Subject: Supplementary Information on Proposed Changes for the AP1000 Design Control Document Rev. 18

This letter provides additional supplementary information on the design change (Change Number 74) which addresses improvements to the design for containment external pressure. Information on CN74 was initially provided in Reference 14. Supplementary information for Reference 14 was provided in Reference 20. The additional supplementary information, which consists of additional responses to comments provided by the NRC at various times, is provided in Enclosures 1 - 3. Responses provided in Reference 20 are also included. In those cases where resolution of the comment required changes to NRC Review Package pages, those revised report pages are provided in Enclosure 4. Enclosure 5 contains information on the Vacuum Relief System flow path which was requested by Enclosure 3 Comment 31.

Supplementary Information for CN74
AP1000 Containment Vessel External Pressure Analysis and Design Information for Change Number 74
Responses to 20 Comments Plus 5 Additional Changes
Non-Proprietary

Vacuum Relief System Flow Path Description

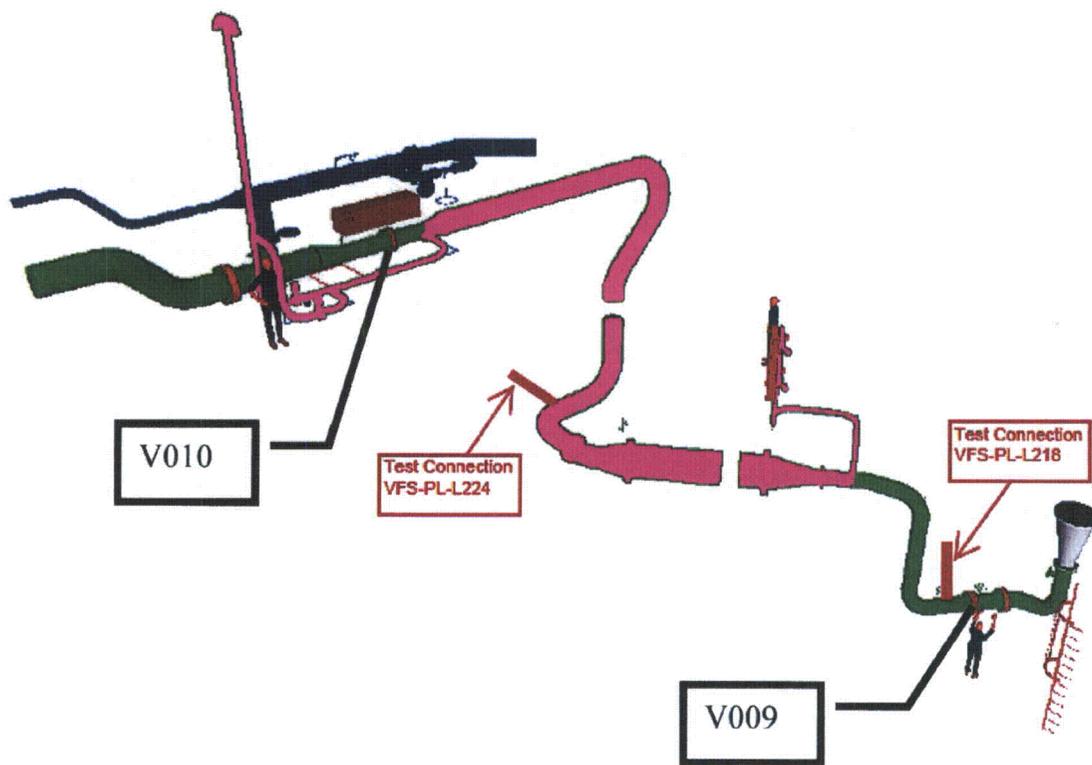
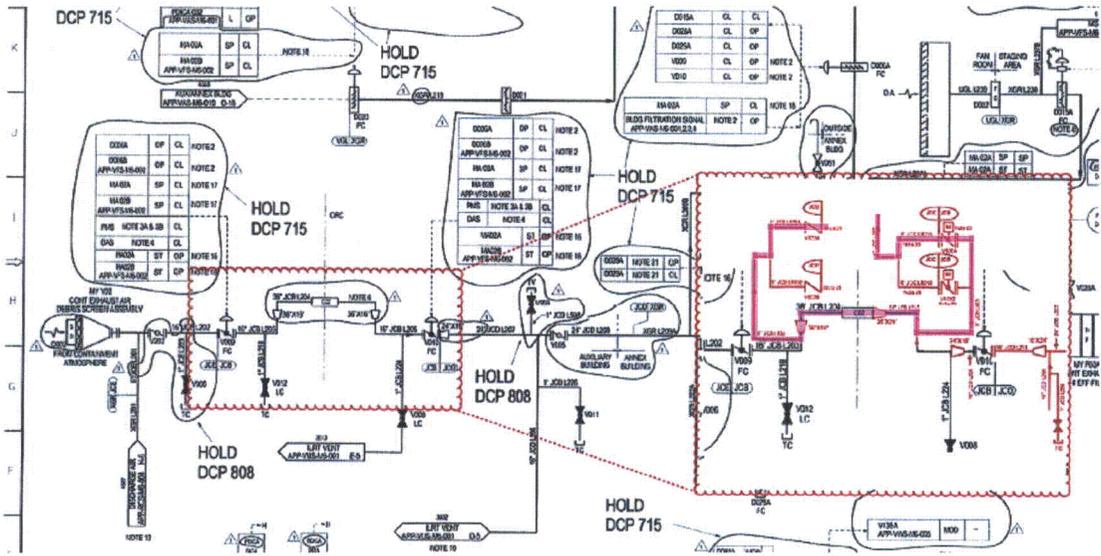
31	DCP_NRC_002941	Provide a description of the complete flow path for the AP1000 vacuum relief system to allow the NRC staff to review any piping or components that are not currently identified in AP1000 DCP 74 submitted on July 30, 2010.	No change required: Please see Enclosure 5 titled "Vacuum Relief System Flow Path Description" for a description of the Flow Path.

Upon activation of the vacuum relief system, outside air enters through two, open-ended, gooseneck fittings located on the roof of the Auxiliary Building above the VAS Fan Room 12553. The air then travels through a 6" pipeline (L800) before splitting into two 6" pipeline paths (L801A and L801B). Each path contains a single, 6" motor-operated butterfly valve (V800A or V800B). The airflow then recombines into a single 6" pipeline (L803) before entering a 16" pipe via a branch, tee fitting. The 16" pipe then expands into a 24" pipe and then expands again into a 36" pipe before penetrating containment at VFS Containment Penetration C02. Immediately after the penetration there is a very short run of a 36" pipeline (L204) that reduces to 16" (L203). From the 16" (L203) pipeline there is a branch tee that the airflow travels through into a 6" pipeline (L804). Once again the airflow splits into two streams on its way to one of two 6" check valves (V803A or V803B) located in 6" pipelines (L805A or L805B). Once the air passes through either one of the check valves (V803A or V803B) is released to the containment atmosphere.

Figure 1: External Pressure vs. Time for the -40°F/70% Humidity Transient (Sensitivity 1)

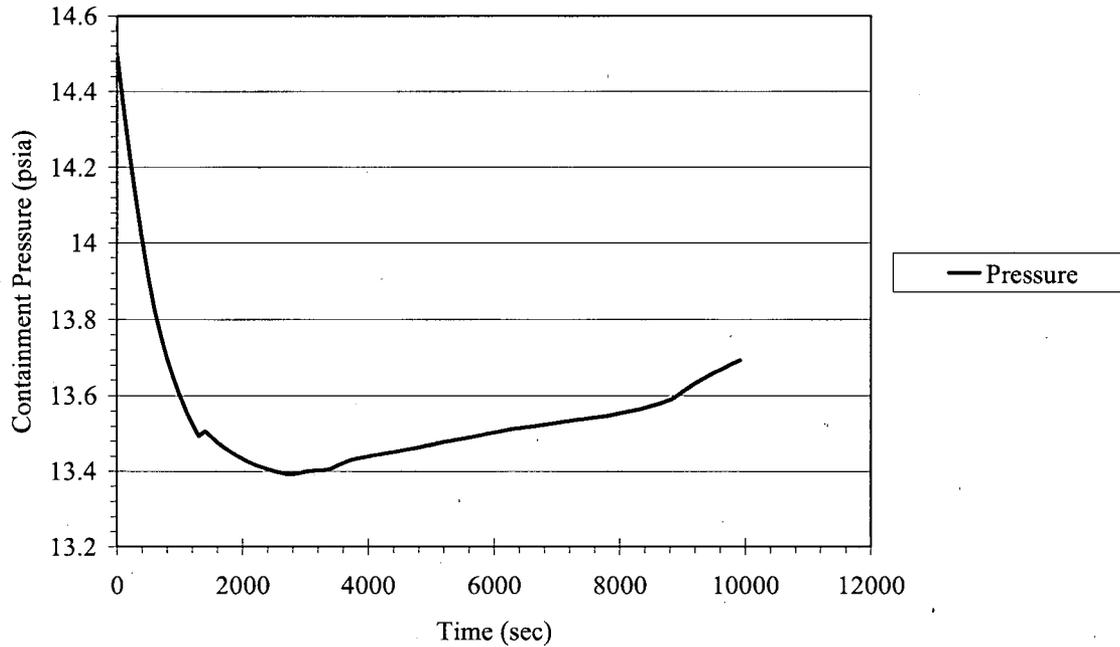
NRC Comment 14 (Enclosure 3):

Sensitivity 1 was performed at -40°F with an assumed 70% humidity inside containment. All relevant assumptions regarding the modeling of the vacuum relief system from APP-SSAR-GSC-112 Rev. 0 were used. Figure 1 shows resulting pressure excursion associated with Sensitivity 1. For the previously identified bounding scenario (25°F @ 100% humidity) the magnitude of the external pressure is 1.54 psid. For Sensitivity 1 the maximum external pressure was calculated to be 1.31 psid. This is in agreement with the bounding results depicted in APP-SSAR-GSC-112 Rev. 0. Sensitivity 1 is formally documented in APP-SSAR-GSC-112 Rev. 1 as Case 11.

Figure 3: Regional Climate Zones

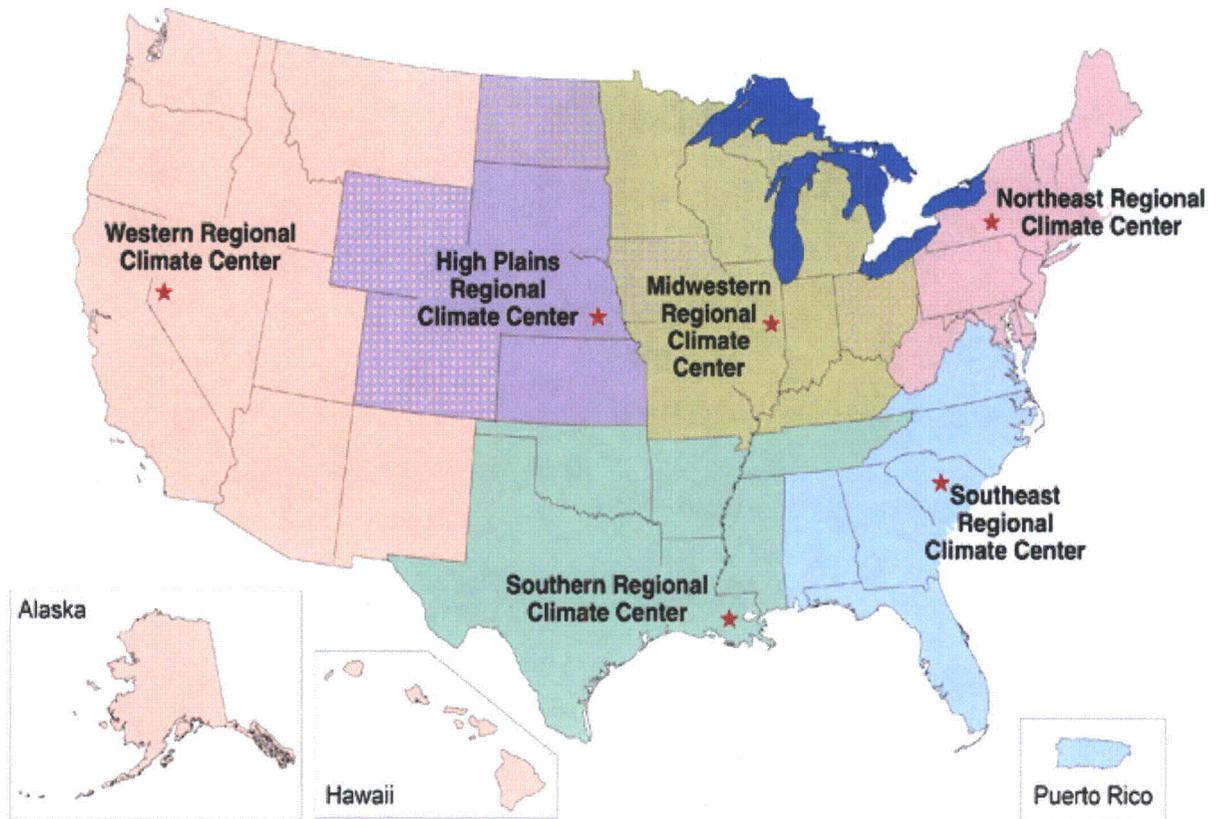
NRC Comment 15 (Enclosure 3):

Sensitivity 3 was performed to address the staff's question regarding external temperature variations. To determine a bounding scenario for an external temperature decrease a 30°F/hr temperature decrease was assumed. This assumption was based on an evaluation of meteorological data gathered at the Charlotte, NC international airport from 1/1/1973 to 6/24/1996, and Duluth, MN from 1/1/1975 to 1/1/2010. Charlotte, NC was chosen due to its proximity to Chapel Hill, NC (140 miles) which is the location of the Southeast Region Climate Center, and due to the quality and longevity of the available data. Chapel Hill, NC was investigated, but there were interruptions in the available data in some cases spanning several years. Airports generally provide a better quality and source of meteorological data. For these reasons Charlotte, NC was chosen to convey stereotypic meteorological behavior for the Southeast Region. Duluth, MN was chosen because it represents the basis for the AP1000 DCD minimum allowable operation temperature of -40°F.

Figure 6.2.1.1-11

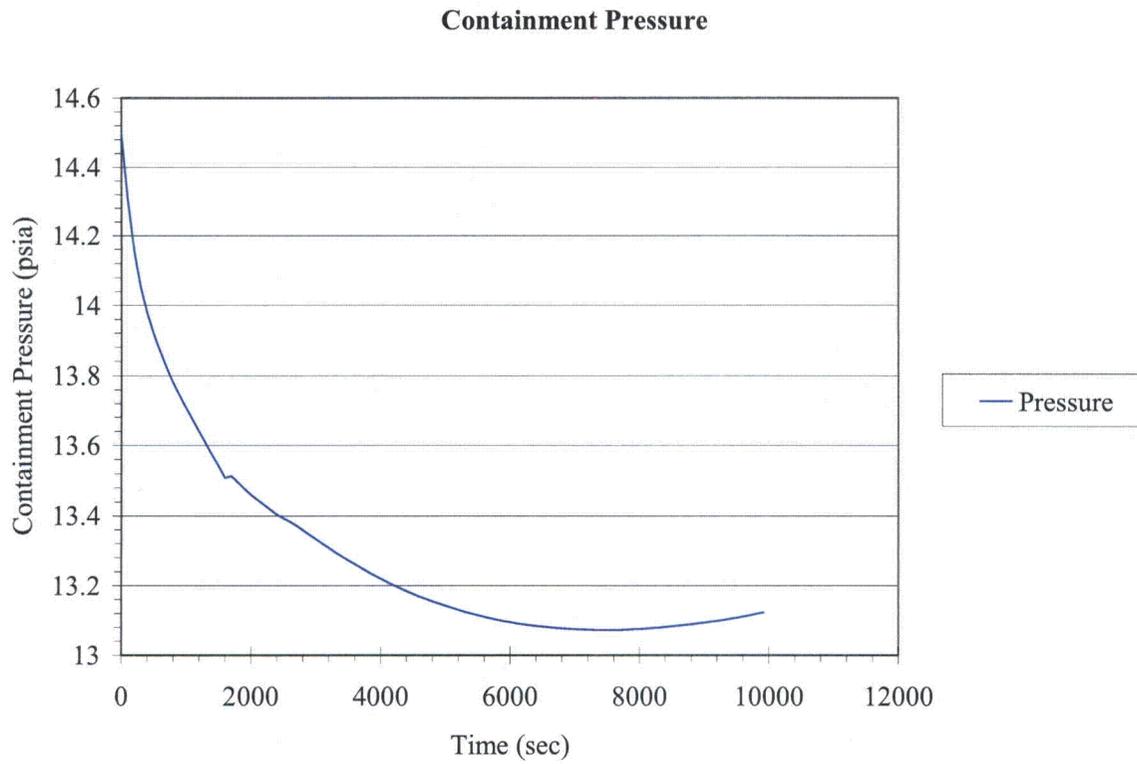
12	Tier 2, Chapter 6 Figure 6.2.1.1-11	NRC – Figure 6.2.1.1-11 on vacuum relief, vertical axis should be “pressure” instead of “temperature”	Incorporated: Figure 6.2.1.1-11 has been replaced with the new design basis curve.

Figure 6.2.1.1-11	External Pressure Analysis	Figure 6.2.1.1-11 has been revised to reflect the new containment pressure transient analysis.
Table 6.2.3-1	Containment Mechanical Penetrations and Isolation Valves	Since the proposed vacuum relief system valves are included as part of the containment air filtration vent line, valves VFS- PL-V800A/B and VFS- PL-V803A/B have been added to the table with the following actuation signals: Closes on Containment Isolation, High Radiation, and Opens on Low-2 Containment Pressure. Notes 8 and 9 were added to the Table. Note 8 addresses the Low-2 containment pressure to open the valve. Note 9 addresses testing of valves V800A/B in the reverse direction. Added stroke time of 30 seconds for valves VFS- PL-V800A/B .
Text 6.2.3.5	Instrumentation and Control Application	Statement addressing the priority logic of the containment vacuum relief signal was added.
